**Yukon Utilities Board
(YUB)**

1 **REFERENCE:** **Application - Overview, Energy & Peak Load Changes, pages 1**
2 **to 4**

4 **ISSUE:** **Energy and Peak Load Changes (8.4% of revenue shortfall)**

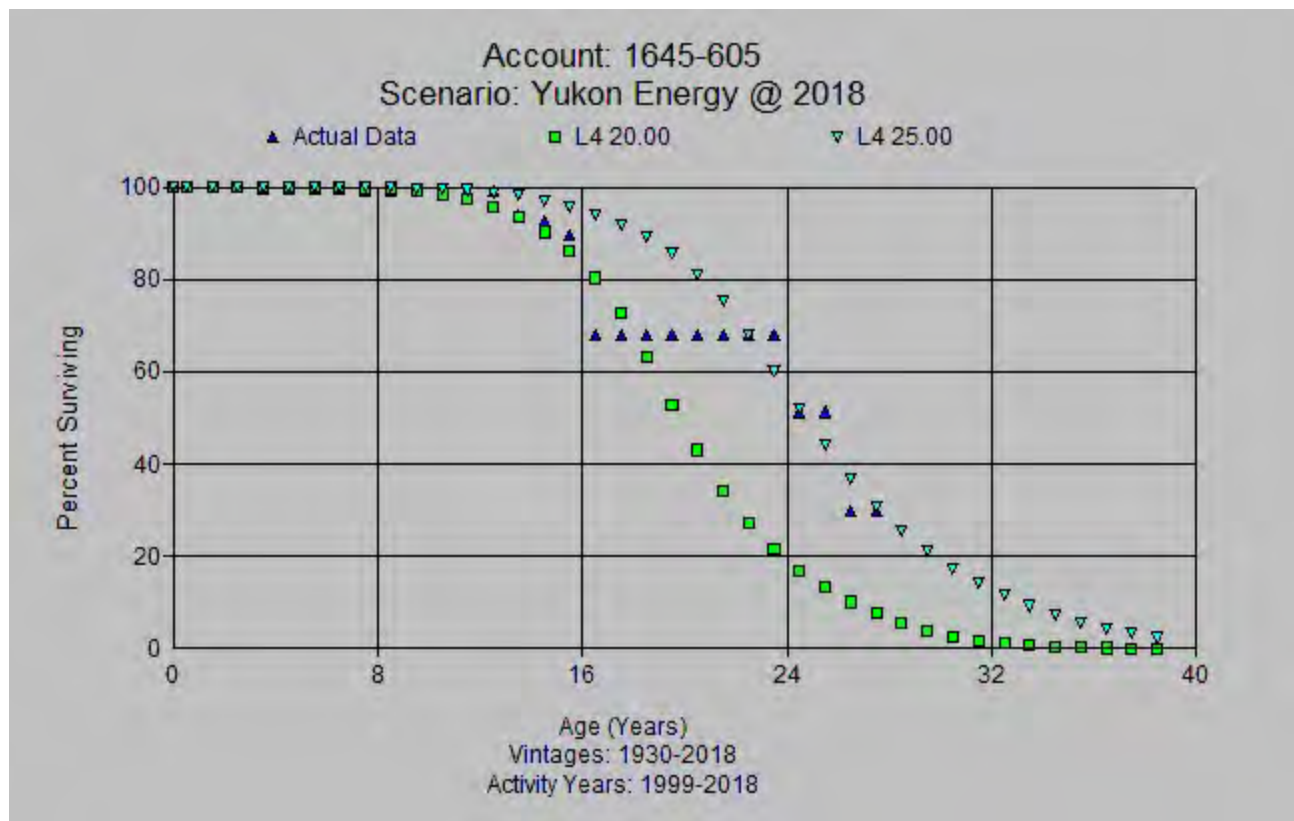
- 21
22 a) Please provide an observed life table and the plotted actual data points showing
23 both a 20-L4 and 25-L4 survivor curve for this account.

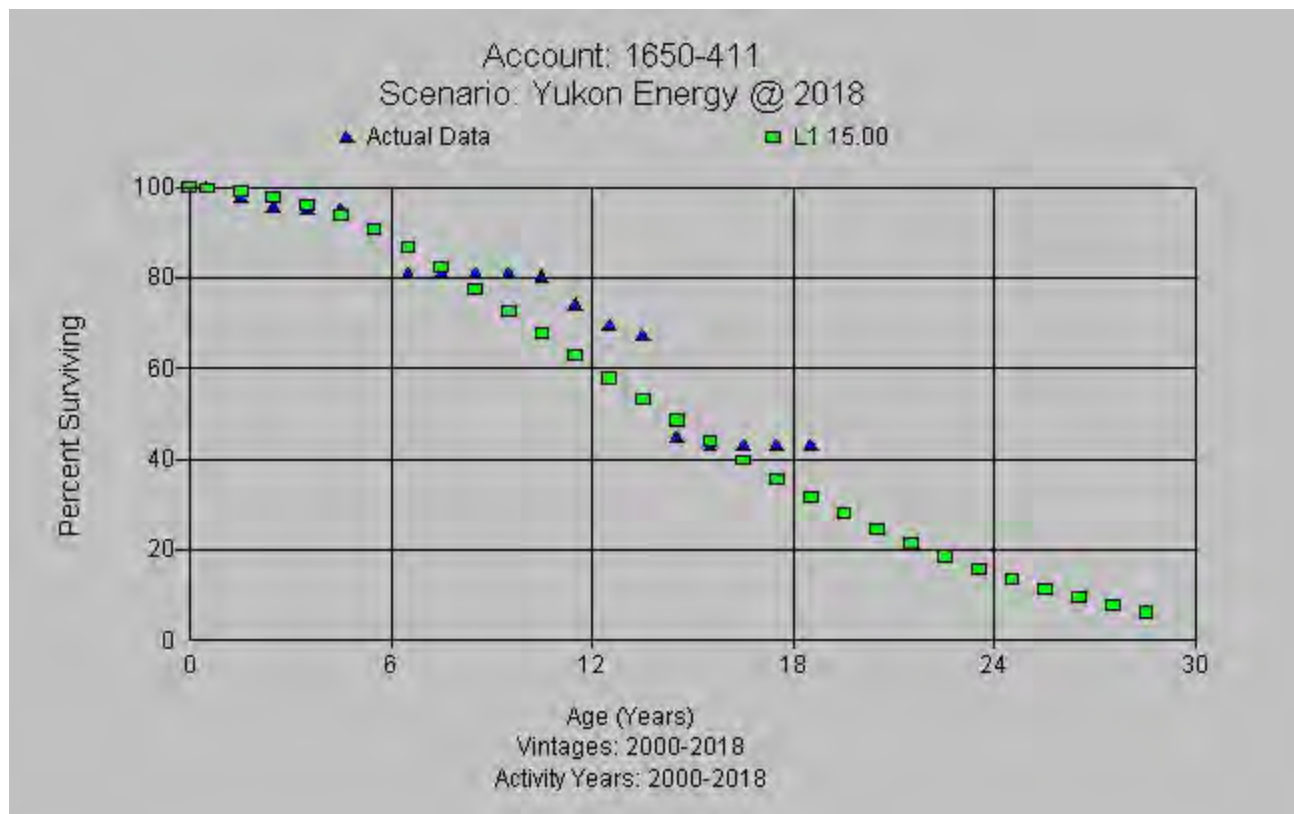
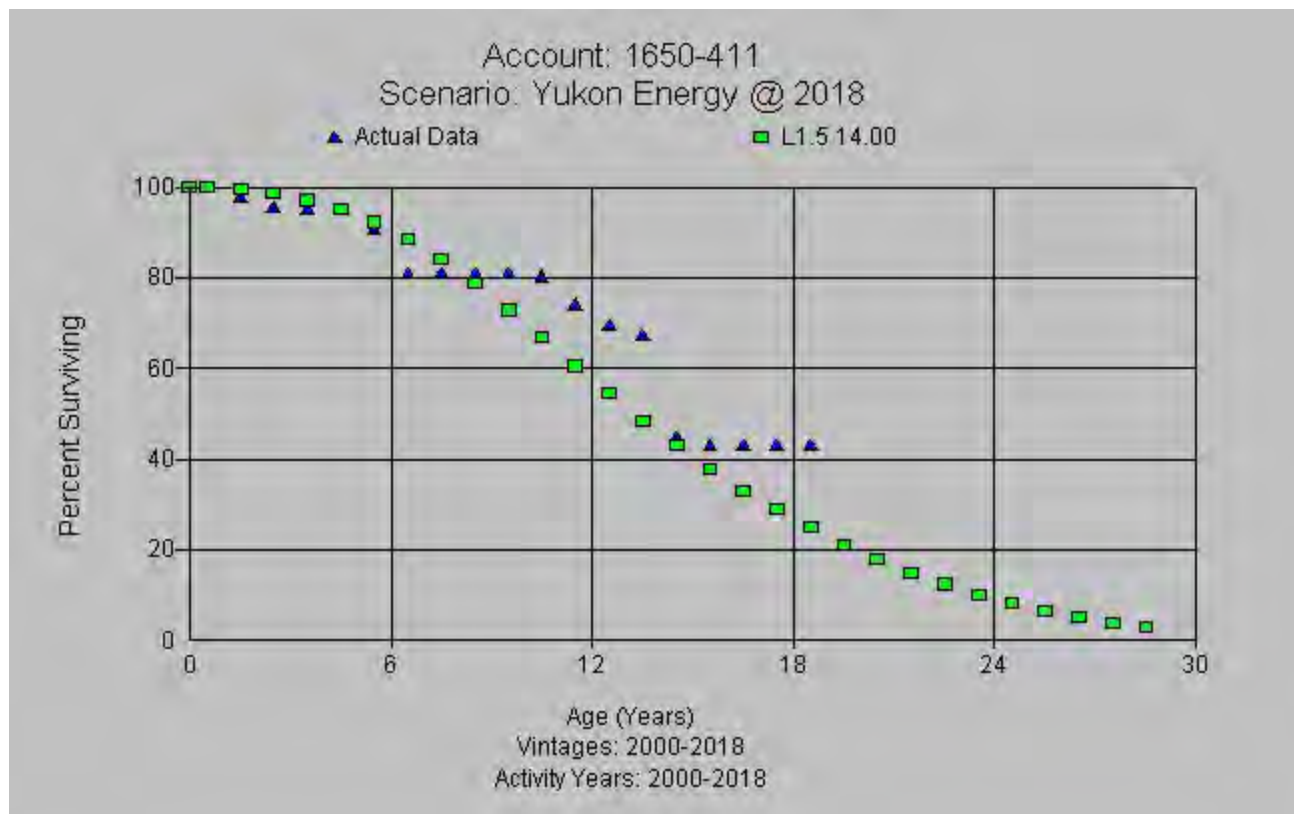
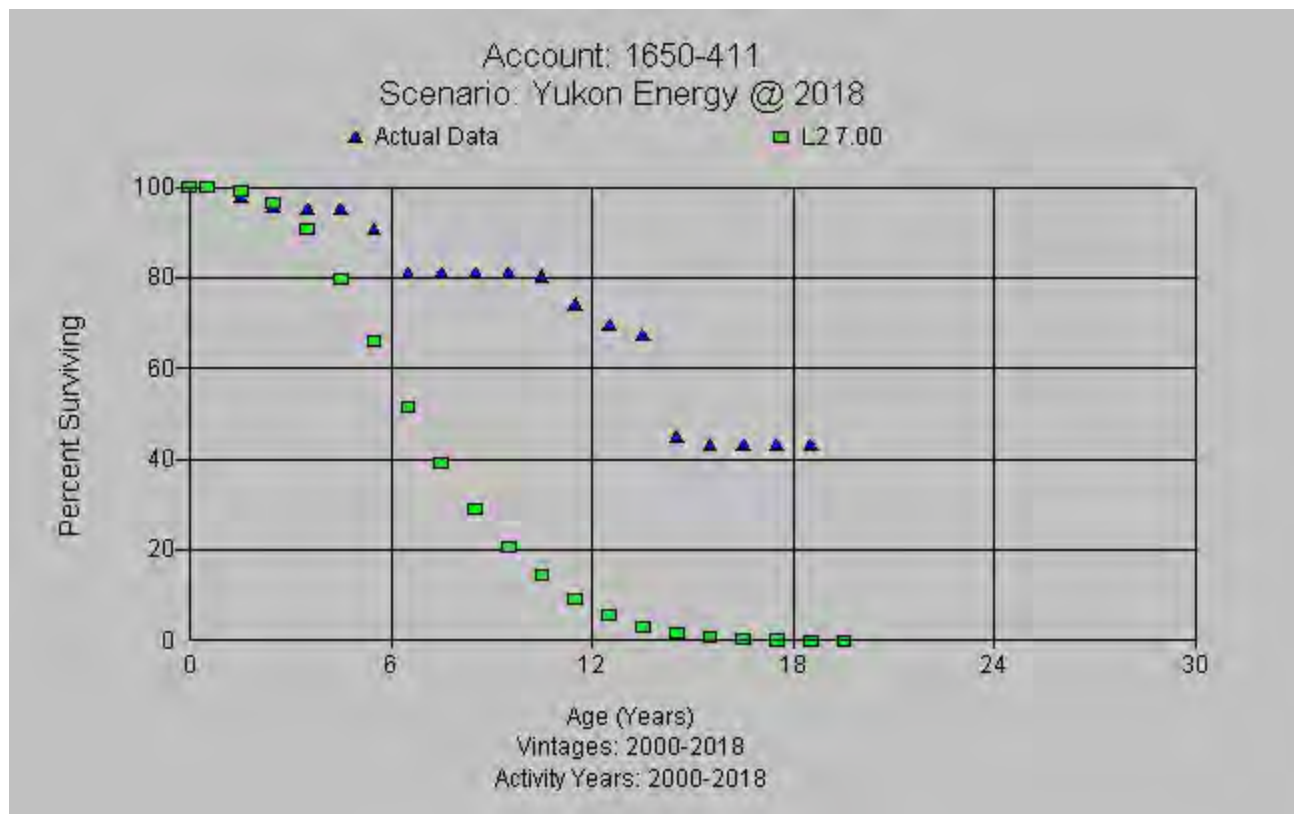
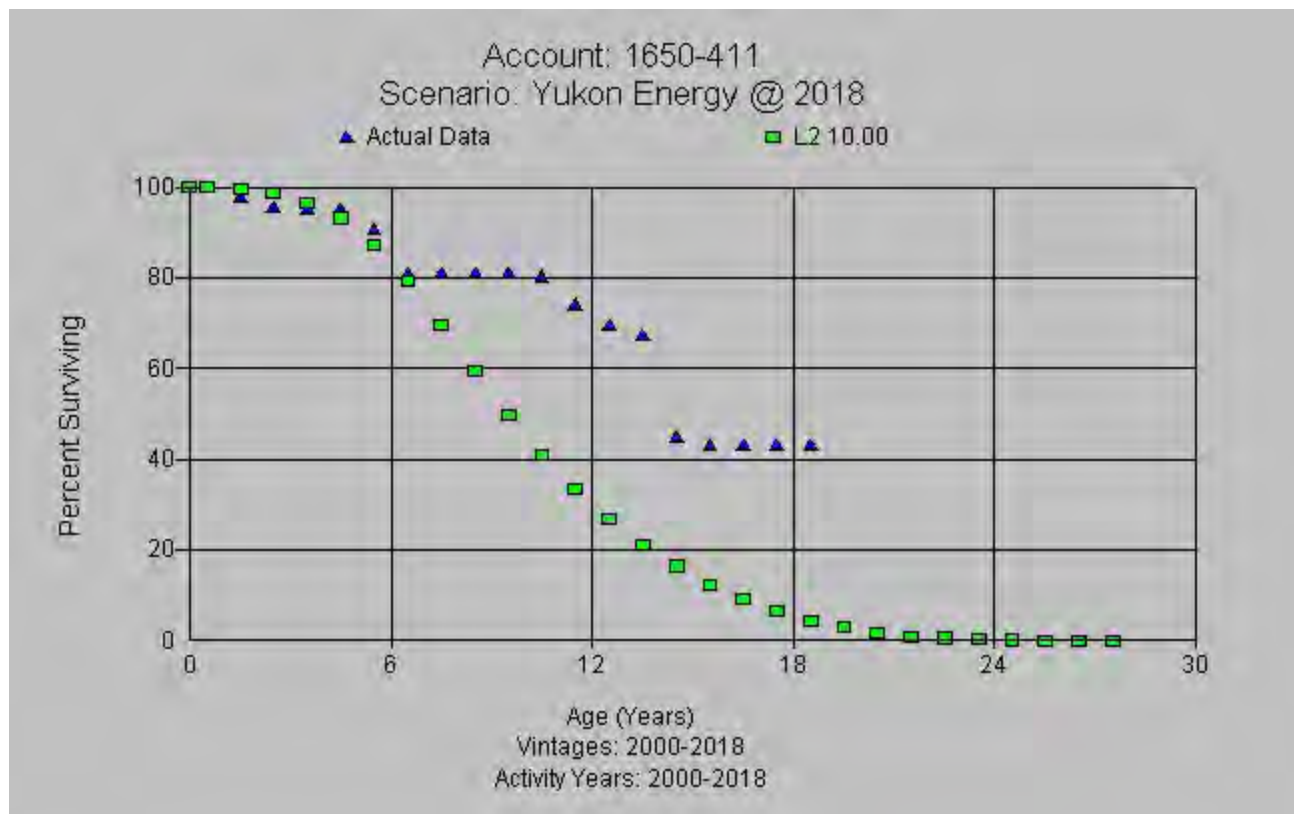
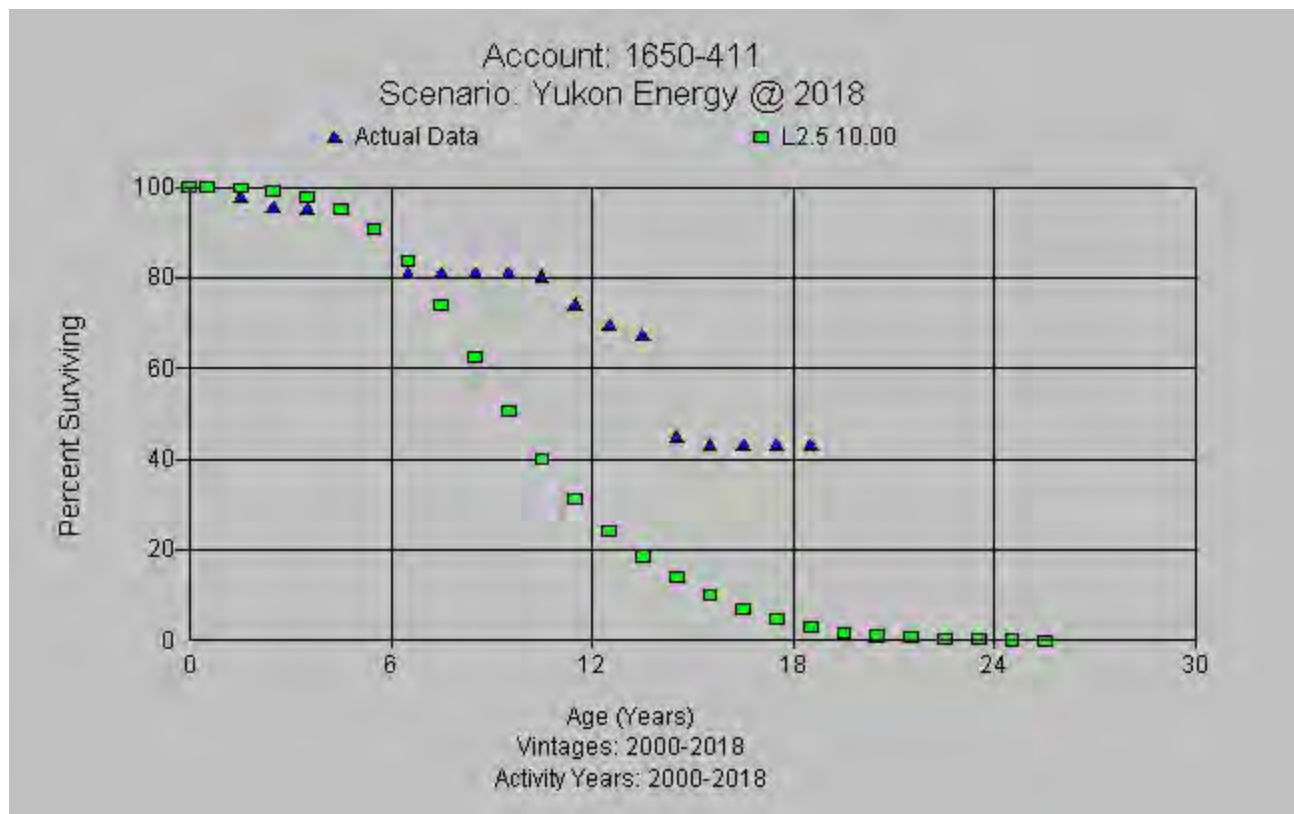
- 21
22 a) Please provide the "life analysis indicat[ing] a longer life than existing and longer
23 than what the Company expects, which ranges from 10 to 15 years".

28
29 The requested information is provided as Attachment 1 to this response.
